APPLICATION NO.	FILING DATE	FIRST NAMED INVENTOR	ATTORNEY DOCKET NO.	CONFIRMATION NO.
10/528,207	03/17/2005	Harald Hagen	11138-018	4540
<div>757                      7590                      06/06/2007 BRINKS HOFER GILSON &amp; LIONE P.O. BOX 10395 CHICAGO, IL 60610</div>				
			EXAMINER RIPLEY, JAY R	
			ART UNIT 3679	PAPER NUMBER
			MAIL DATE 06/06/2007	DELIVERY MODE PAPER

<b>Office Action Summary</b>	<b>Application No.</b> 10/528,207	<b>Applicant(s)</b> HAGEN, HARALD	
	<b>Examiner</b> Jay R. Ripley	<b>Art Unit</b> 3679

## **DETAILED ACTION**

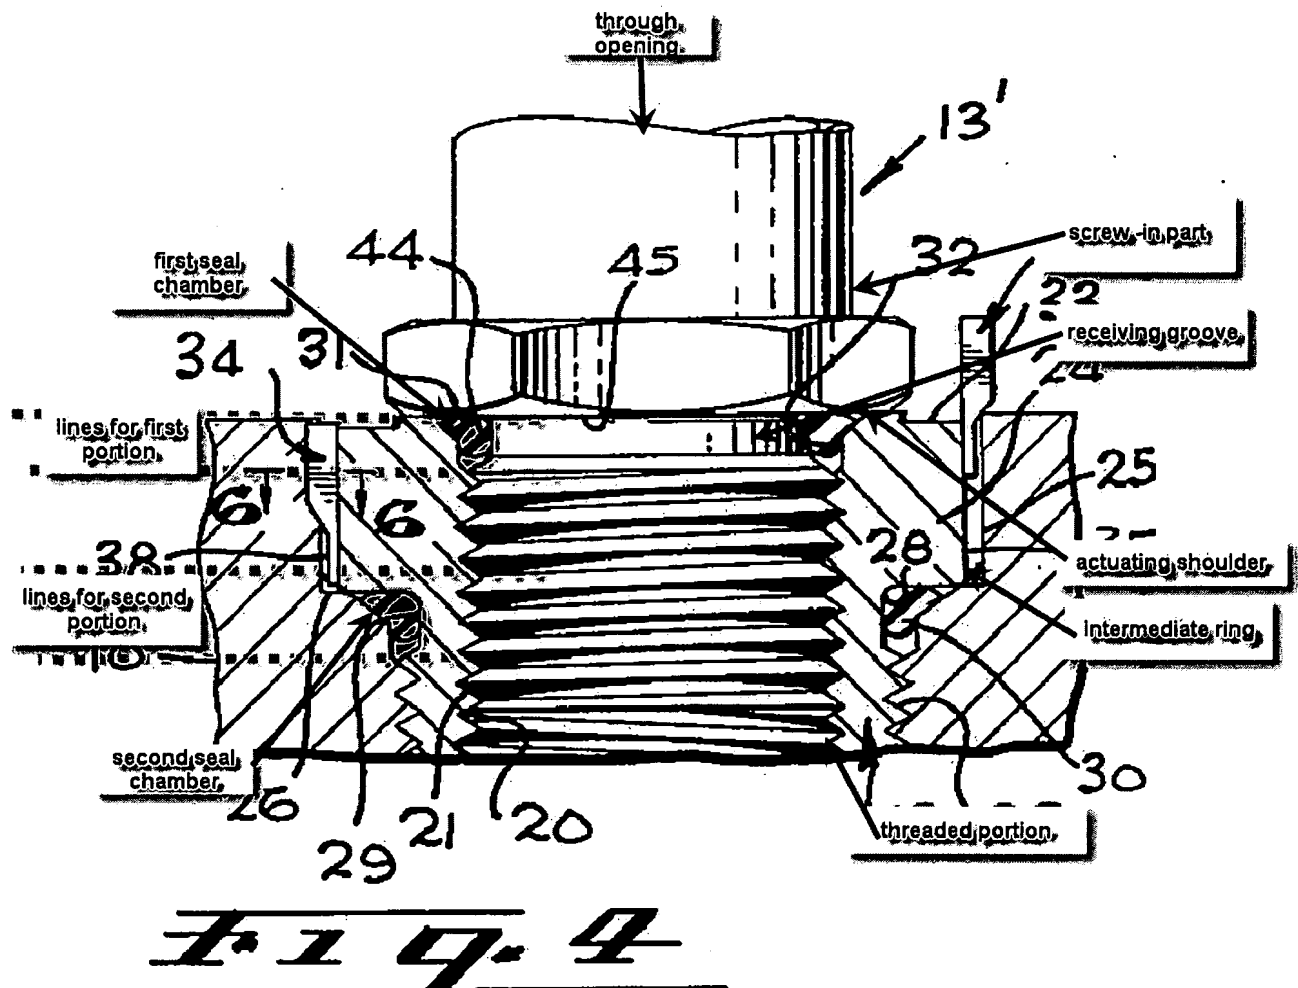
7. In regard to claim 1, Neuschotz, in Figure 4 below, discloses an adapter assembly comprising:

a screw-in part having a through-opening, an externally threaded portion having an outer thread diameter, an actuating shoulder having an outer shoulder diameter being larger than the thread diameter (as can be observed in Figure 4, below, the outer diameter of the actuating shoulder is diametrically further from the central axis than any of the threads shown), and a receiving groove formed in the transition between the actuating shoulder and the externally threaded portion and a first sealing ring being disposed in the receiving groove

the intermediate ring being adapted to fit onto the externally threaded portion (as observed in Figure 4 below, the intermediate ring is on the threaded portion of the screw-in part) and having first and second axially opposite annular planar portions (lines added to marked Figure 4's below to emphasize the portions),

the first planar annular portion having a first sealing ring seat on a first side facing the actuating shoulder, the first sealing ring seat (part 31) and the receiving groove and the actuating shoulder forming a first sealing chamber for the first sealing ring, and

(marked Neuschotz Figure 4)

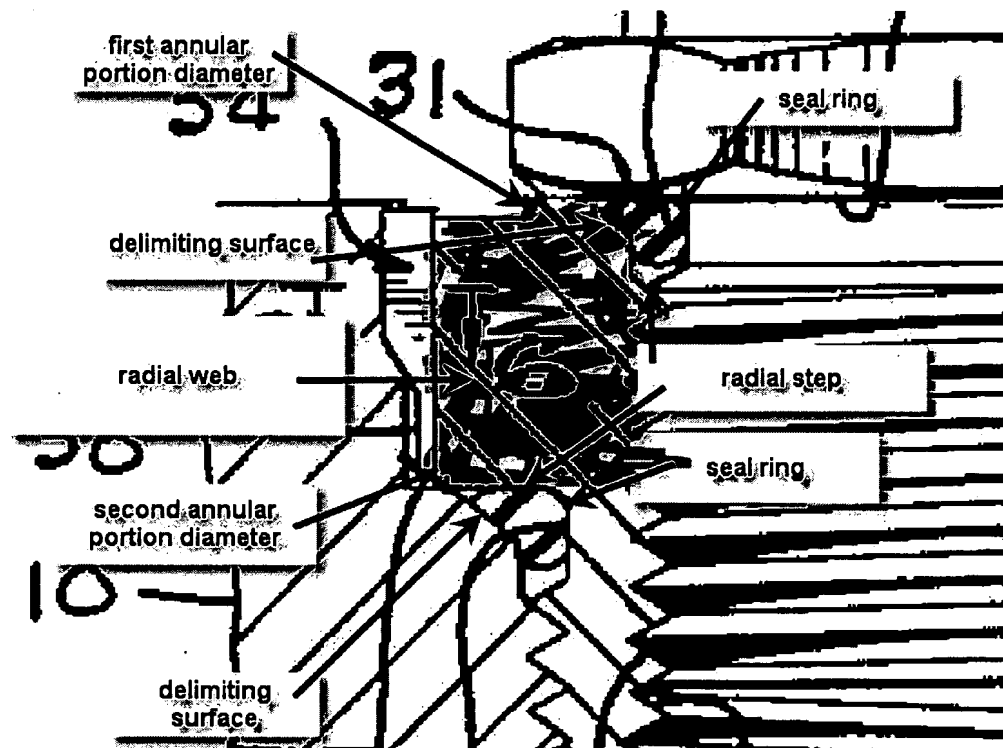
the second planar annular portion having a planar second sealing ring seat on a side facing away from the actuating shoulder for a second sealing ring such that, when the screw-in part is screwed into the threaded bore of the base part, a second sealing chamber for the second sealing ring is formed between the planar second sealing ring seat, the surrounding surface adjacent the threaded bore, and the externally threaded portion of the screw in part.

(marked cut-out Neuschotz Figure 4)

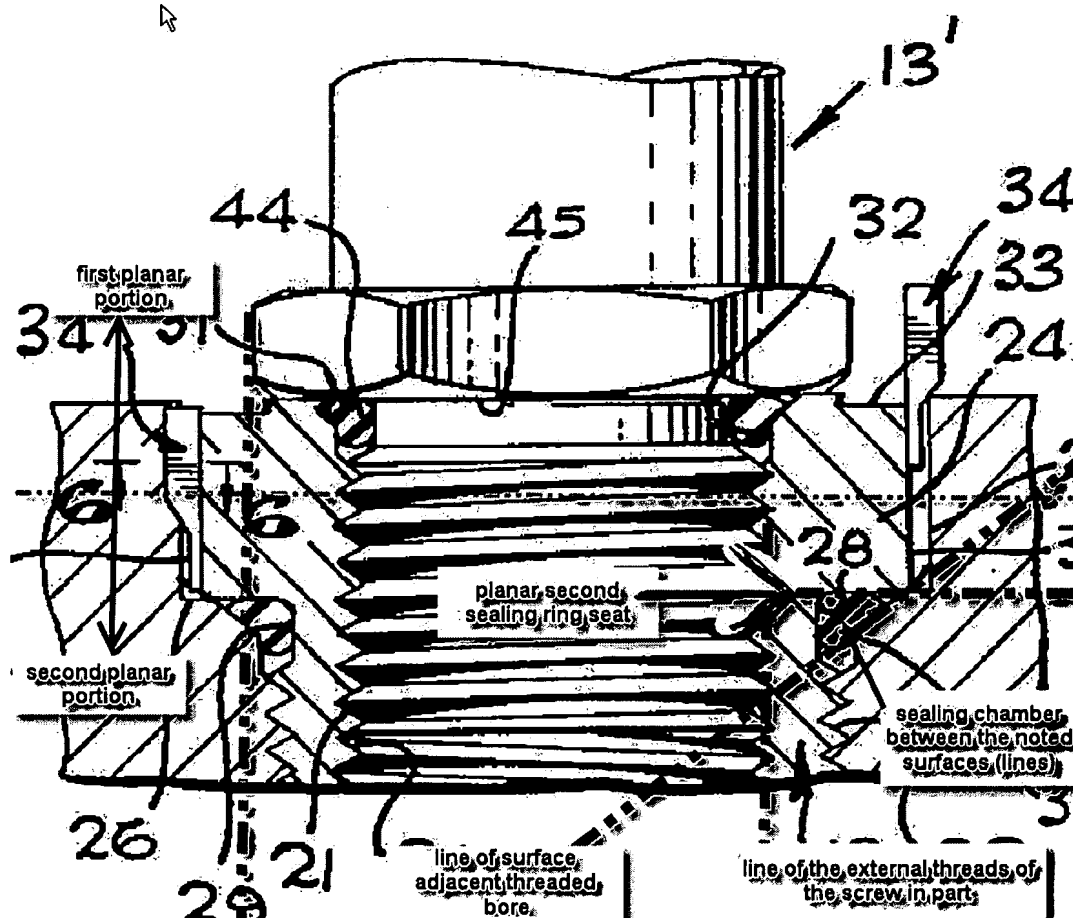
8. In regard to claim 2, Neuschotz further discloses that the first and second sealing ring seats and the associated first and second sealing rings are formed such that, in a mounted state, the first and second sealing rings (as observed in marked cut-out of Figure 4, above) are compressed, the second sealing ring compressed axially without substantial radial deformation against the externally threaded portion (as can be observed in marked cut-out of Figure 4, the second seal ring does not contact the threads).

9. In regard to claim 3, Neuschotz further discloses that the first and the second annular portions are separated by an internal radial web (as observed in marked cut-out of Figure 4 above), which divides the first and second seats from one another.

10. In regard to claim 4, Neuschotz further discloses that the intermediate ring sealing ring seats formed by a radial step surface and an approximately conically widening delimiting surface adjacent to it on the outside (as observed in marked cut-out of Figure 4 above).

11. In regard to claim 6, Neuschotz further discloses that the first annular portion is designed to be smaller in diameter than the second annular portion (as observed in marked cut-out of Figure 4 above).

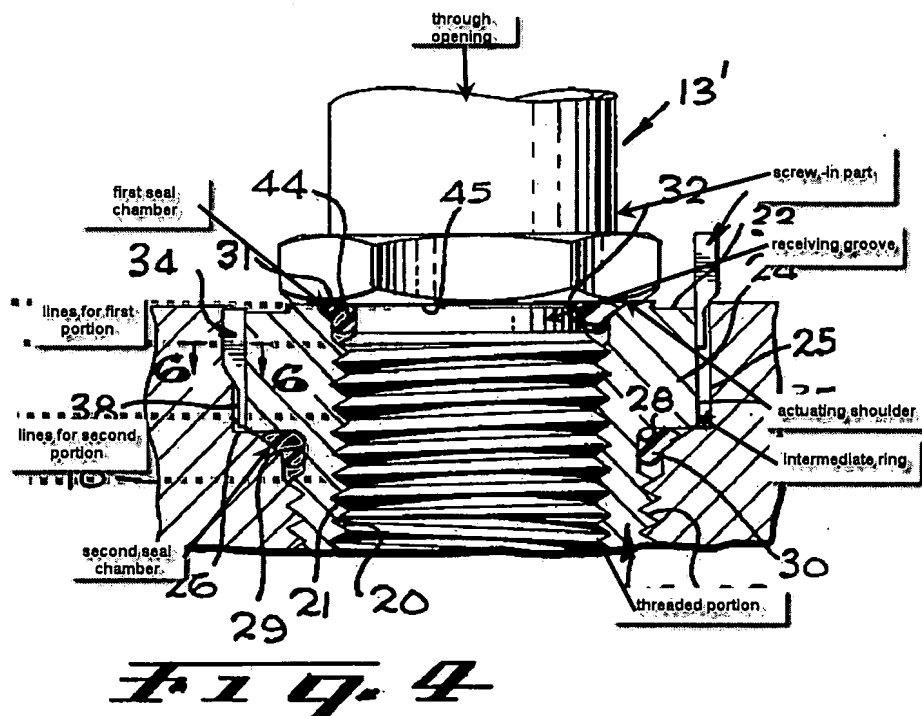
15. In regard to claim 5, Neuschotz discloses the claimed invention except for a plug holding element. Hagan et al teaches an adapter assembly (in patent document Figure 8) with a plug holding element (12) to secure a plug against release (column 1, lines 10-15). As Hagan et al relate to adapter assemblies, it would have been obvious to one having ordinary skill in the art at the time the invention was made to modify the adapter assembly of Neuschotz with a plug holding element as taught by Hagan et al to secure a plug against release.

16. Further in regard to claim 5, the adapter assembly of Neuschotz is capable of being dimensioned such that a gap is formed between an end of a plug part and a bottom of a bore when the plug part is plugged into the screw-in part and engaged with the plug holding element.

(marked cut-out Neuschotz Figure 4)

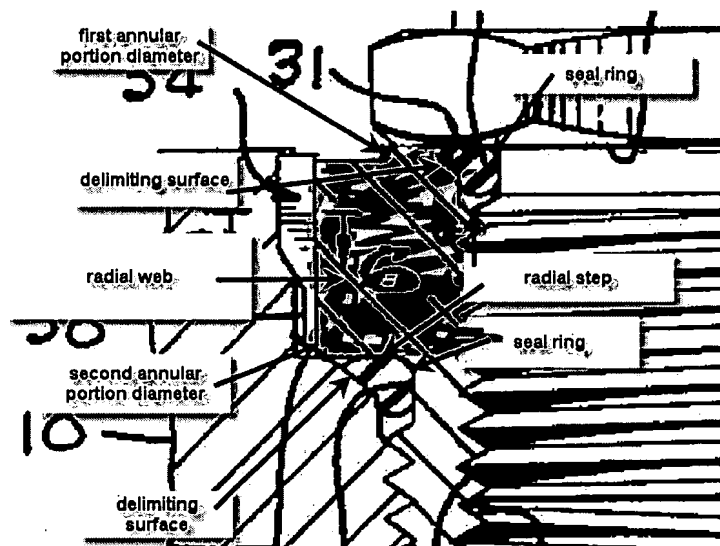
19. Further, the Applicant argues that Neuschotz fails to disclose that “a second sealing chamber the second sealing ring is formed between the planar second sealing ring seat, the surrounding surface adjacent the threaded bore, and the externally threaded portion of the screw in part” as recited in lines 20-23 of claim 1. Neuschotz discloses the claimed structural components, i.e. the planar second sealing ring seat, a surface adjacent the threaded bore, and the externally threaded portion of the screw in part. Further, it is noted that neither term “between” nor the term “adjacent” carry any particular requirements as to closeness of location. “Adjacent”

means: lying near or close. "Between" means: in the position or interval separating. A broad interpretation does not ensure that the noted structural features are the physical boundaries of the second sealing chamber. Neuschotz discloses his second sealing chamber between the noted structural, as shown below in a cut-out of Neuschotz Figure 4. The Applicant's arguments are not persuasive.
